RE: AC Hotel Midtown DC-2 CUP - Revisions

CONDITIONAL USE PERMIT APPLICATION

**AC HOTEL
MIDTOWN DC-2**

**March 1, 2023
Revised June 27, 2023**

TOTAL: 19,047 SF
GUESTROOMS: 39

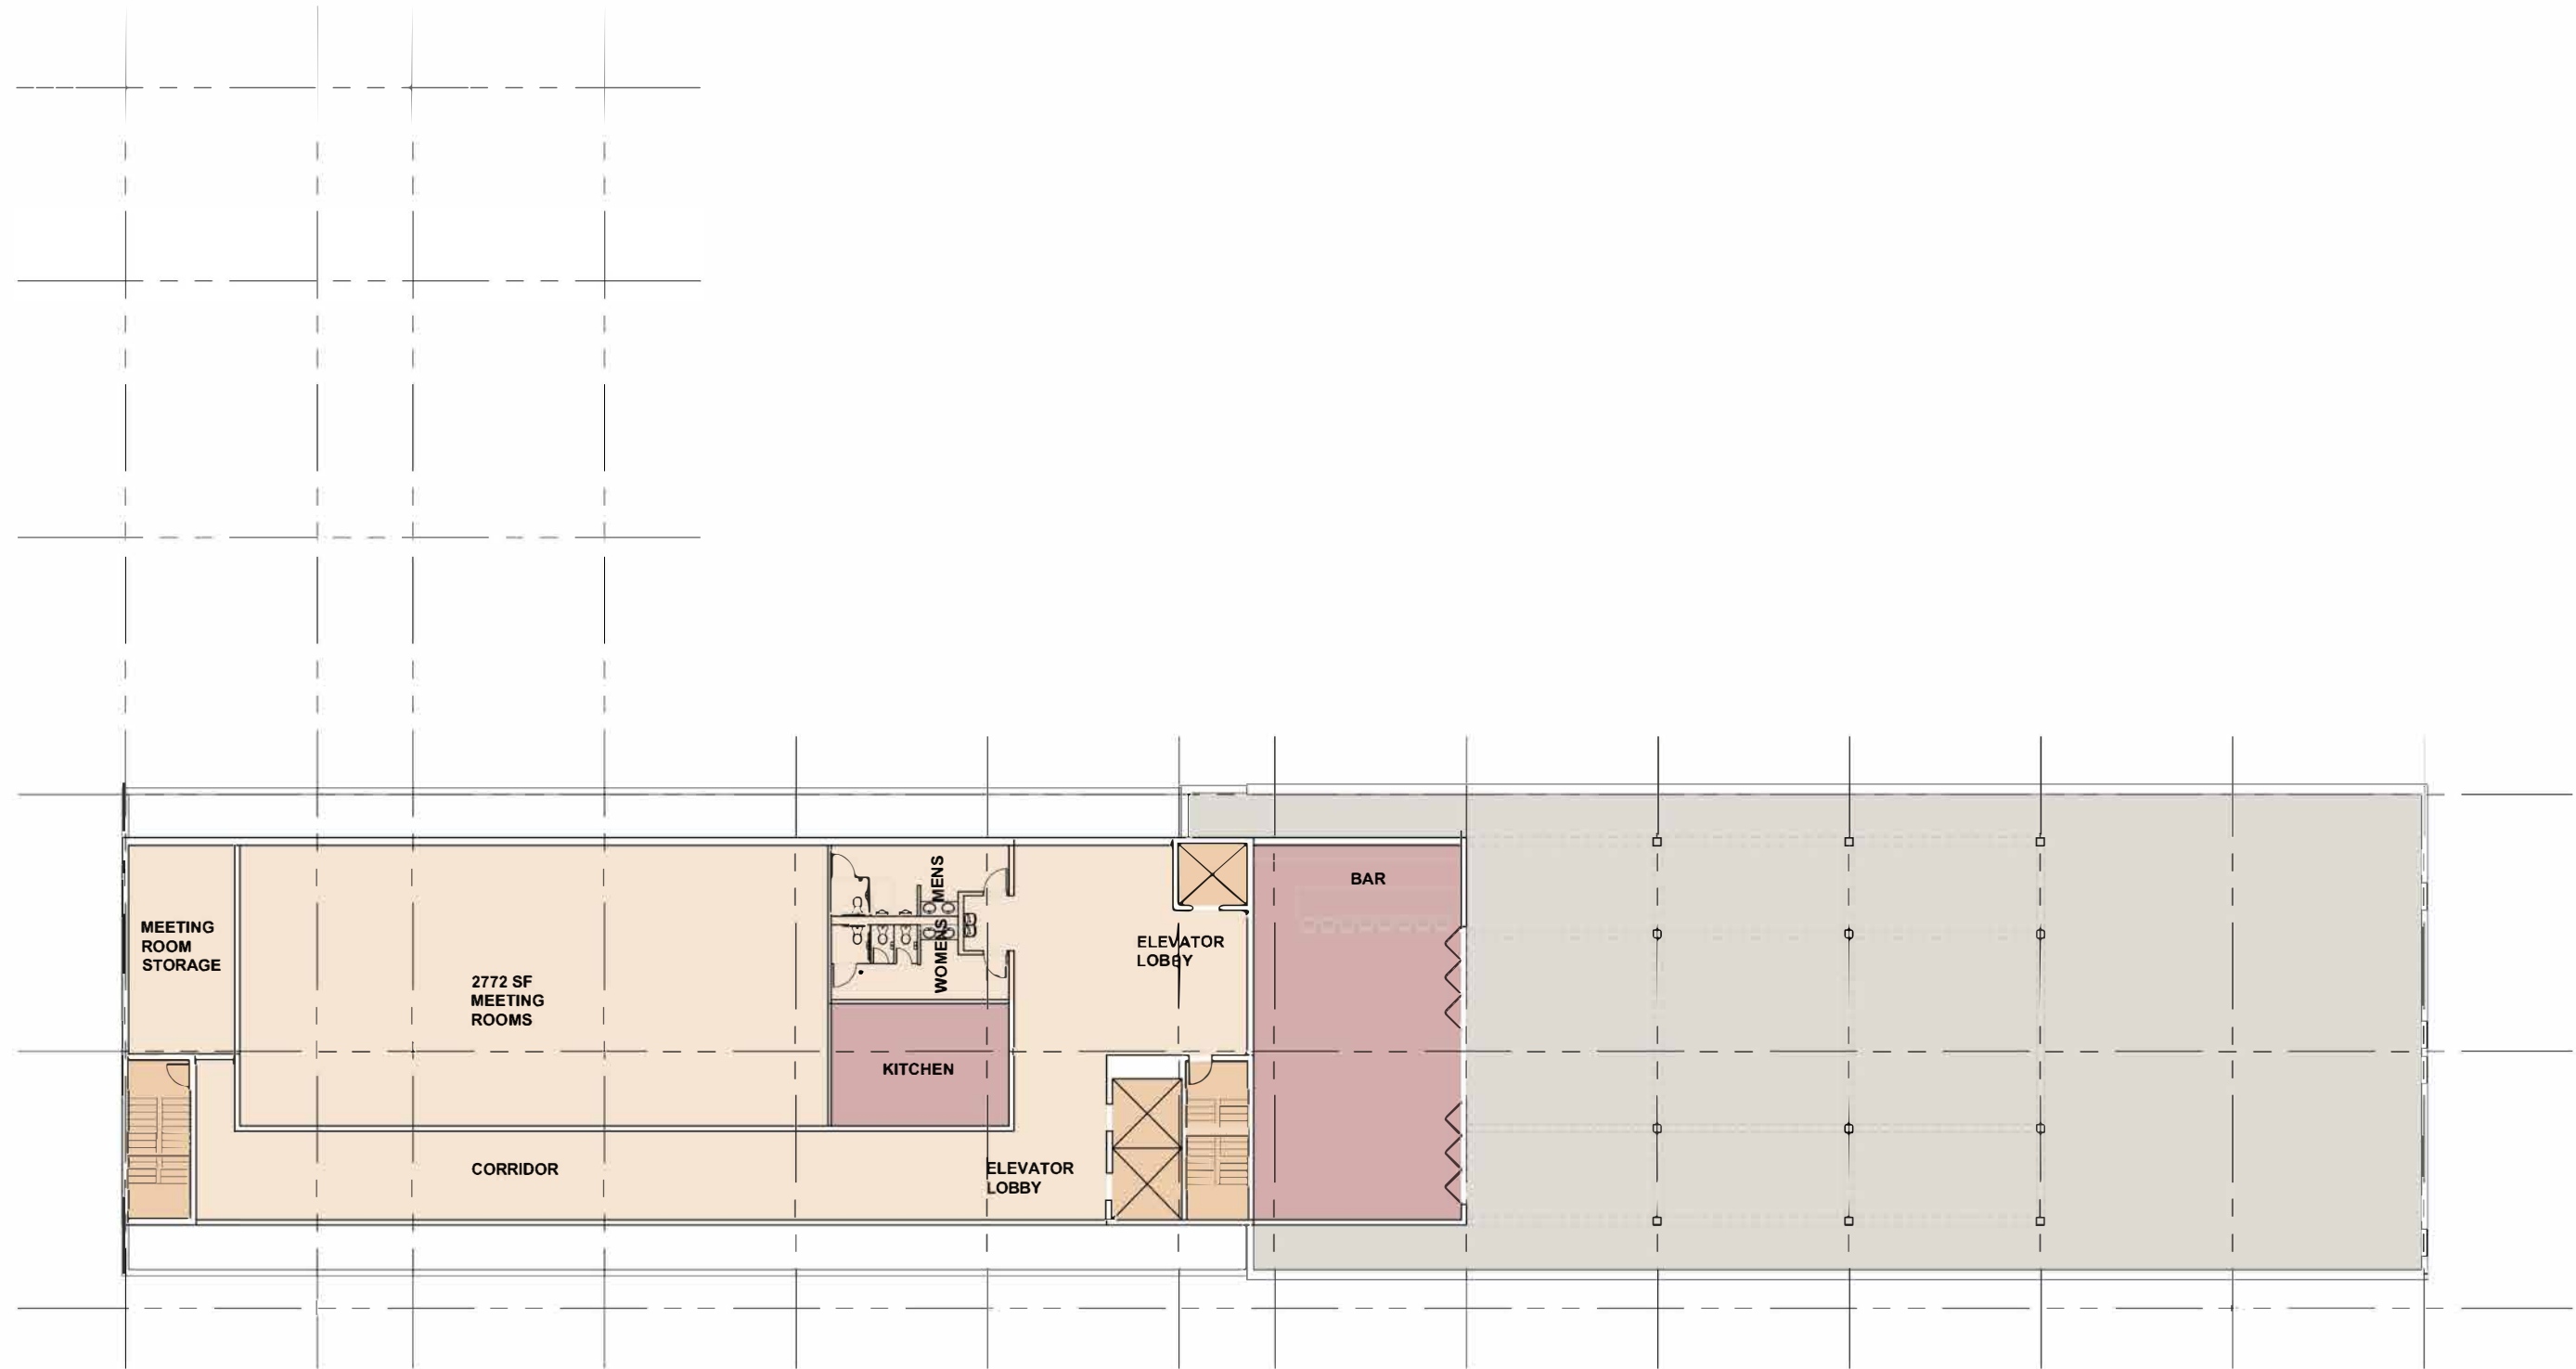
- An additional architectural feature has been added to the upper stories of the building on the southern façade to provide more visual impact and interest.
- Floor plans of the upper floors adjusted slightly to include this new architectural feature.
- Awning structures have been included on the southern façade within the outdoor patio area.
- Lighting has been shown on the interior wall of the patio area.
- The concrete wall along South Main Street has been removed from the perspective renderings and replaced with planter boxes.
- Landscaping is included on the perspective rendering showing the view from The Commons.
- The terracing walls have been removed from the rear of the patio and now match the planned grading and site plan. Landscaping has been shown on this slope.
